## HISTORIC LANDMARK COMMISSION

# PERMITS IN NATIONAL REGISTER HISTORIC DISTRICTS NRD-2019-0075

311 E. 6<sup>TH</sup> STREET

Construct a covered rooftop deck.

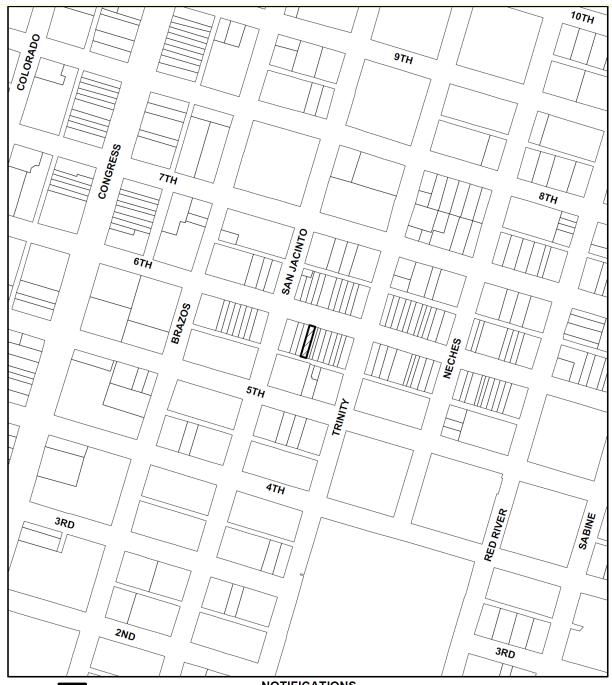
Evaluation: The rooftop activities will be 100% visible from the sidewalk below as the proposed deck is set at the back of the parapet of this one-story building.

Evaluation: While the parapet of these buildings will not be altered through this proposal, the character and roofline of these one-story buildings will be forever compromised.

Evaluation: As designed, the roof deck will be a massive intrusion on the visual integrity of this building.

The Committee recommended against this project and stated that this project violates the sections of the Sixth Street Design Standards which apply to rooftop decks. The Committee stated their preference that the railing be set at least 15 feet back behind the parapets to comply with the standards; more if the rooftop decks are still visible from the street.
